Whitworth Street Planning Comparison

Since planning approval in 2016 the site has been purchased by Vision Manchester Limited. The client has engaged a full design team and RussellWBHO to update the detail design to the required regulations, agree a building contract and construct the development. Through this process a number of design changes are being proposed.

This updated document is being presented to Manchester City Council Planning Department to illustrate and explain the nature and extent of the proposed changes and to seek the Council's formal approval through the necessary planning process.

3.18 Proposed Section BB

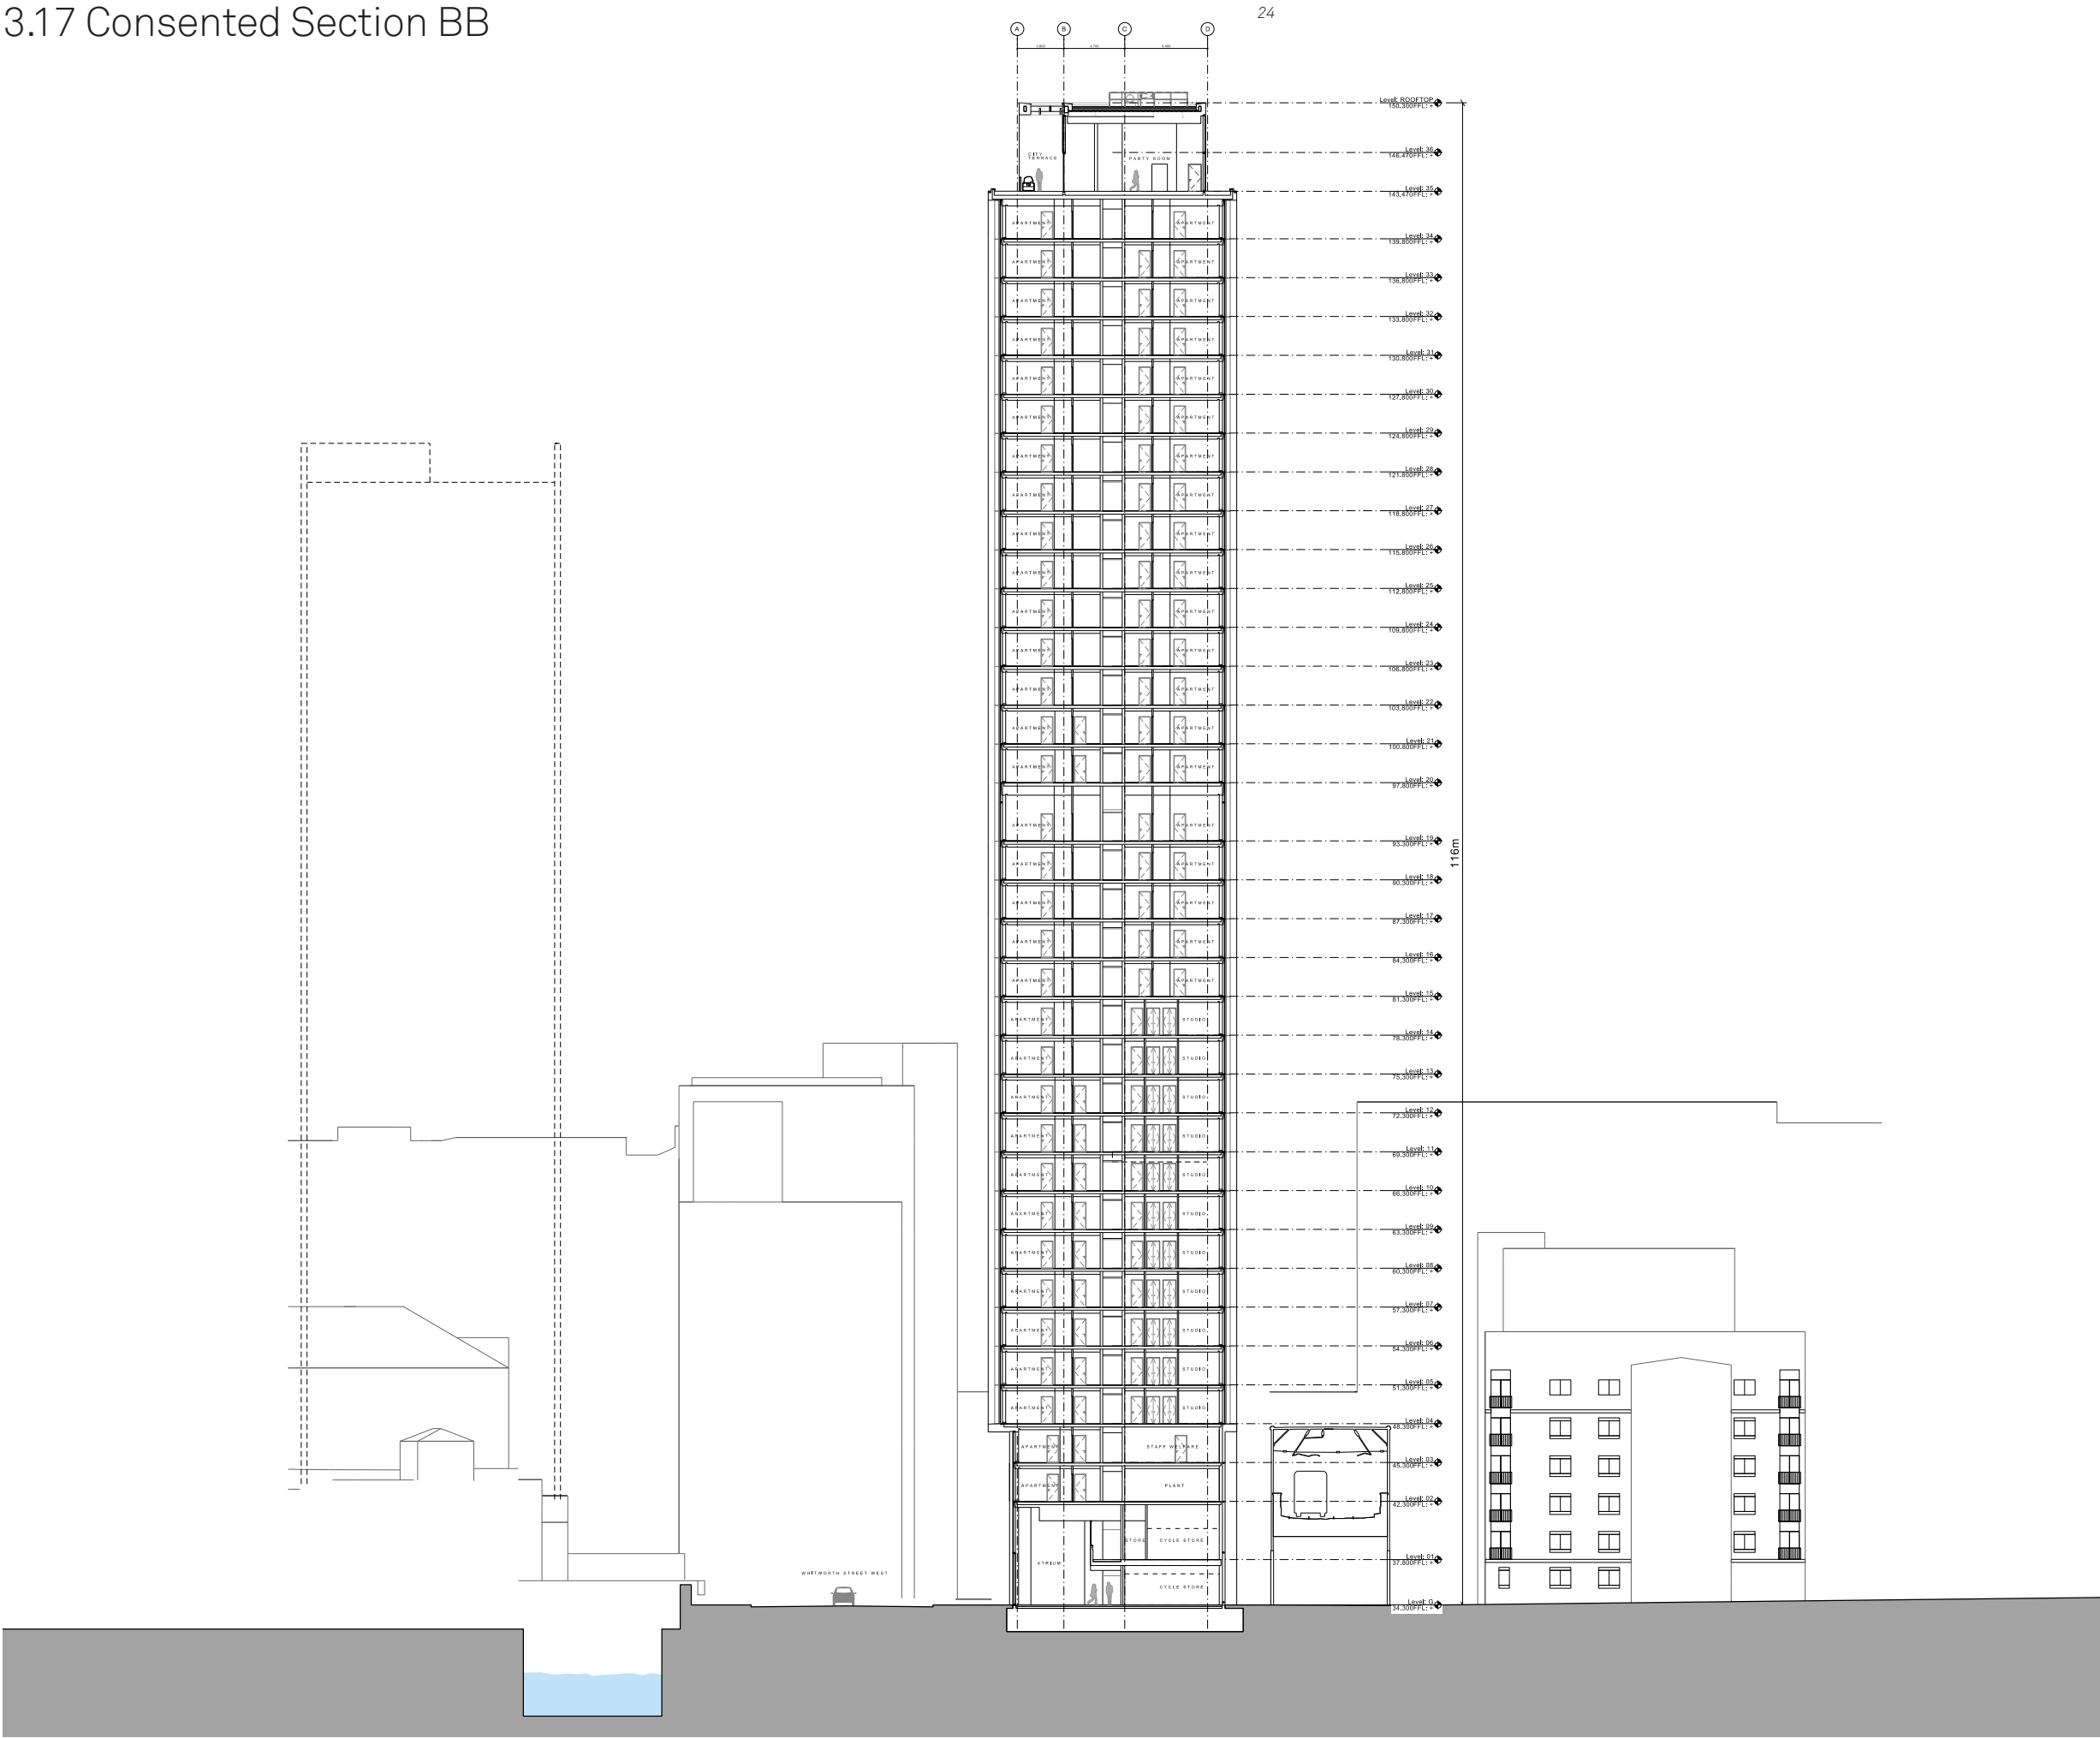
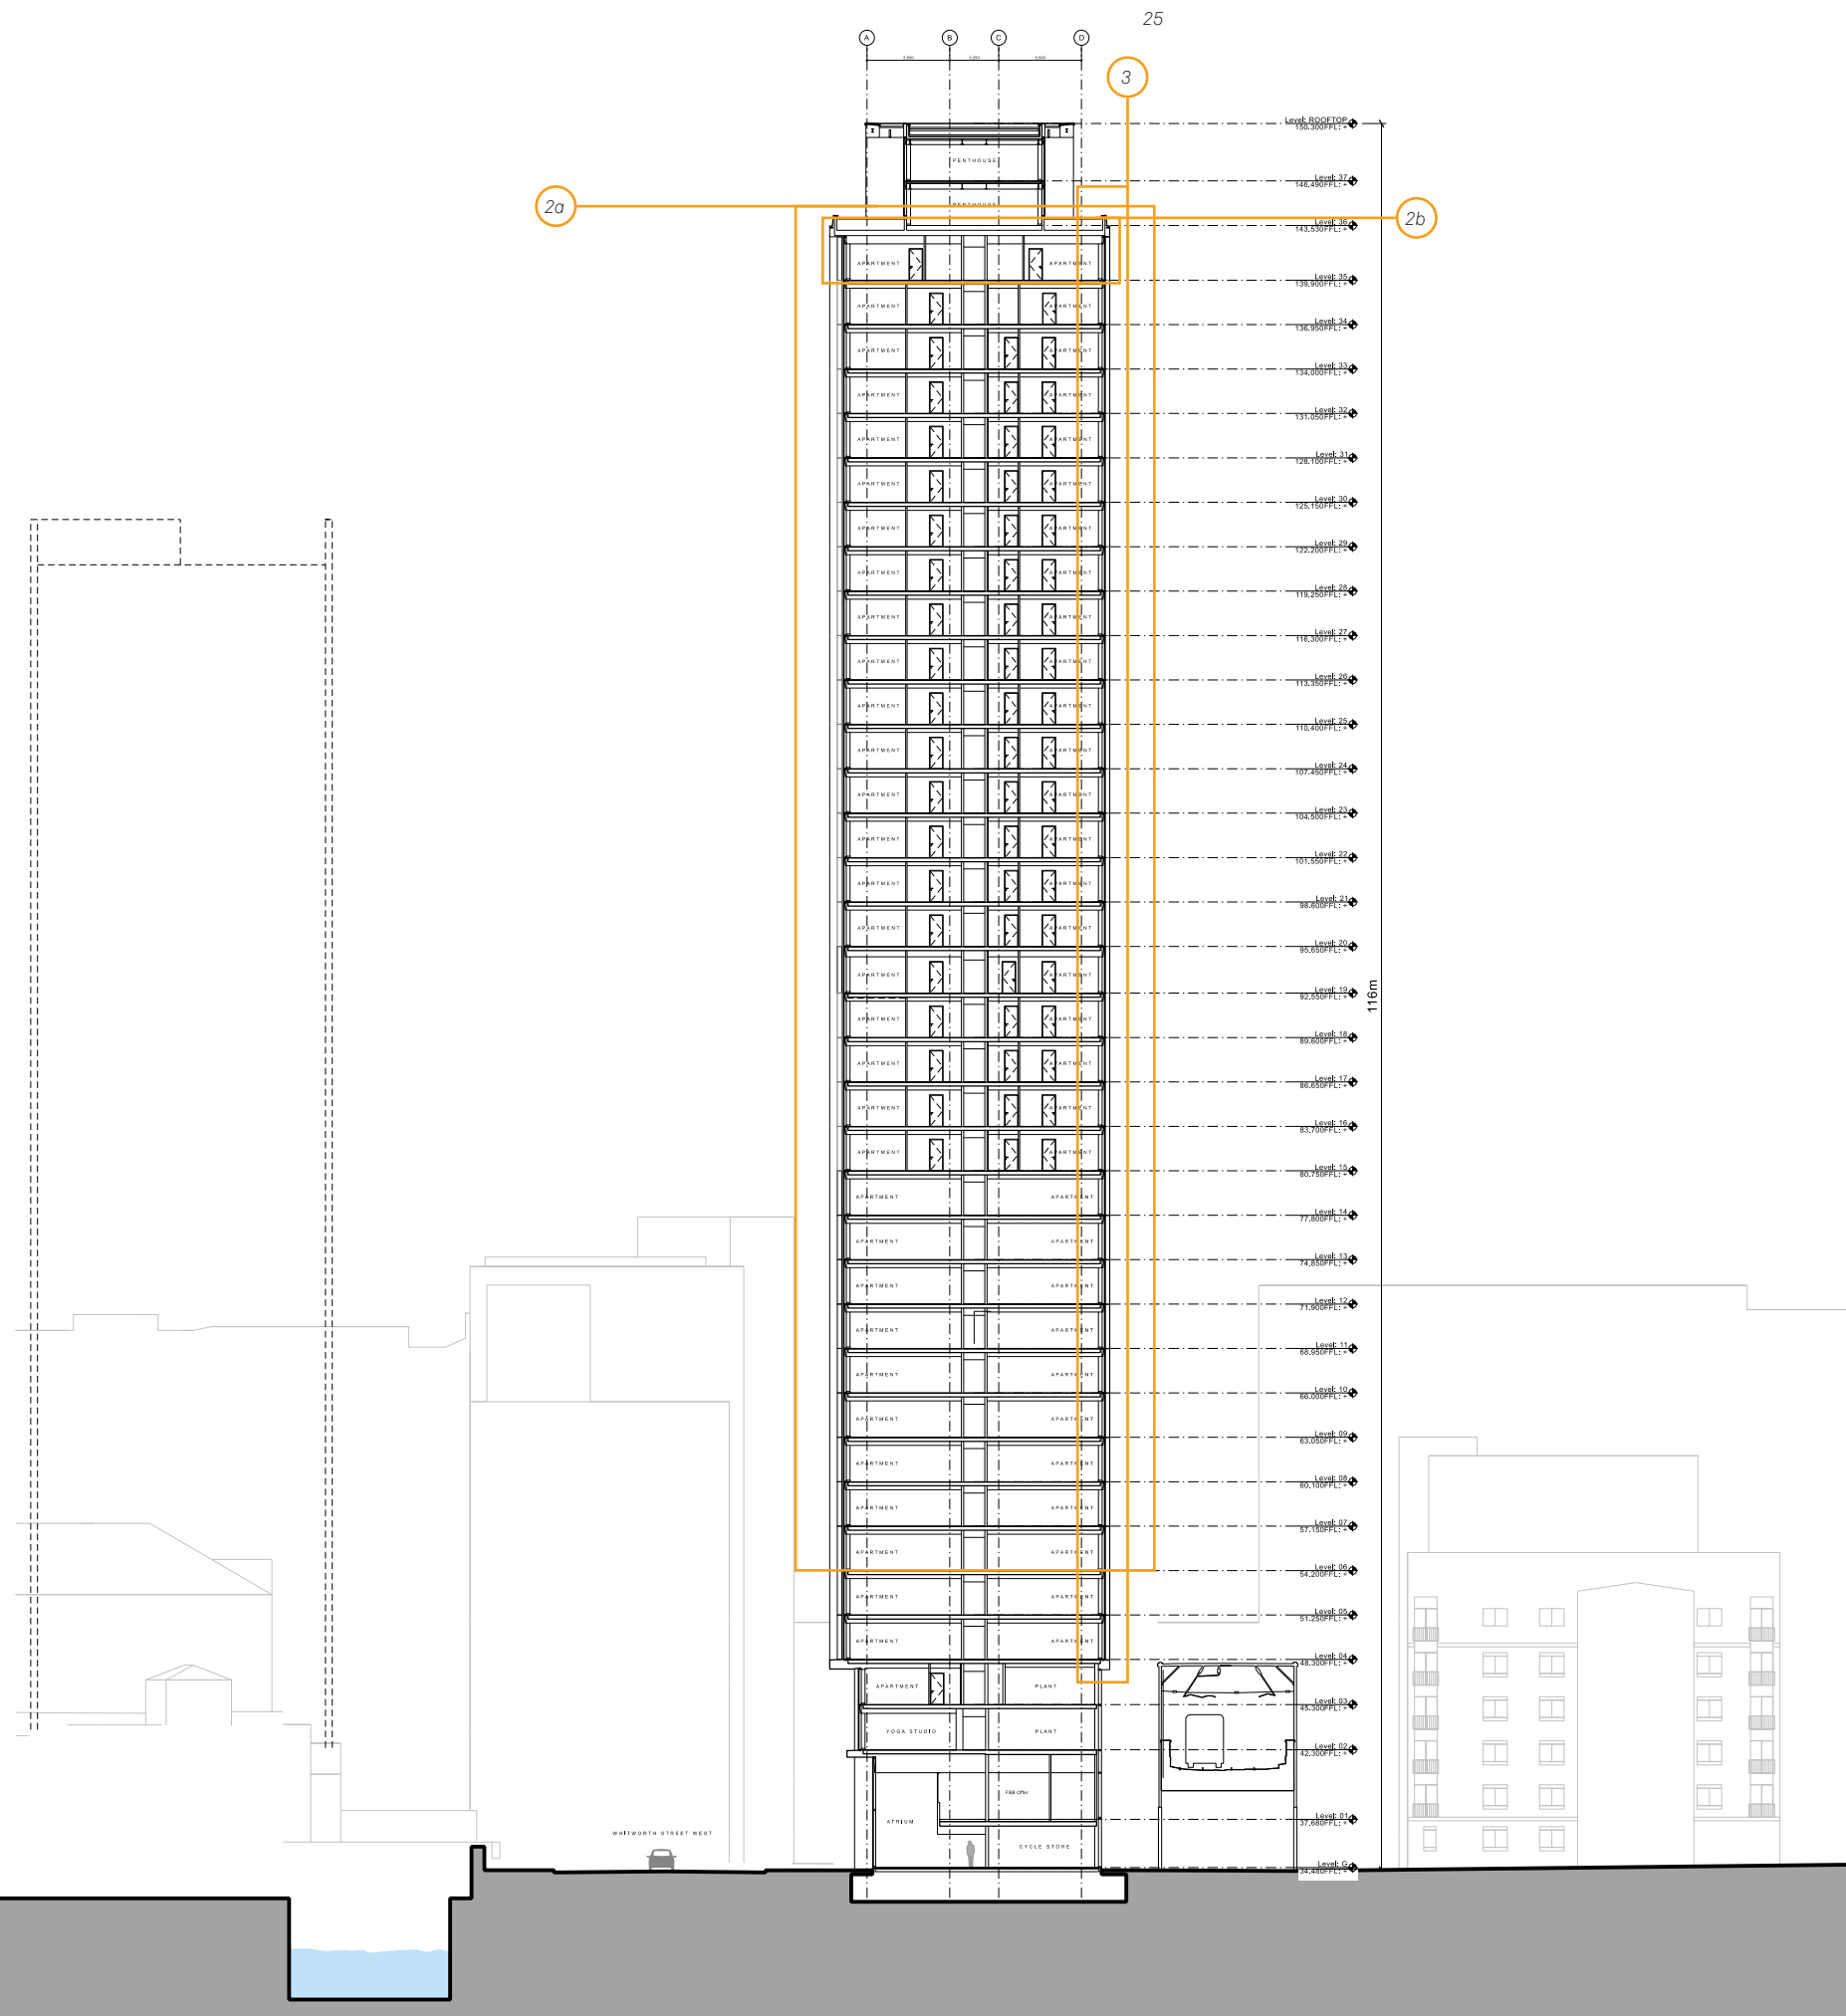
- 1a - Core Repositioned
- 1b - Main body of south facade to match north facade
- 1c - Entrance relocation
- 1d - Form of roof pavilion
- 1e - Apartment & amenity layouts
- 1f - Inclusion of commercial unit & dedicated entrance
- 2a - Reduced floor to floor heights
- 2b - Additional floor
- 2c - 2 no. Guest Beds & 2 no. 1 Bed become 2 no. 2 Bed & 2 no. 3 Bed
- 3 - South 'picture frame' reveal depth reduced by 600mm
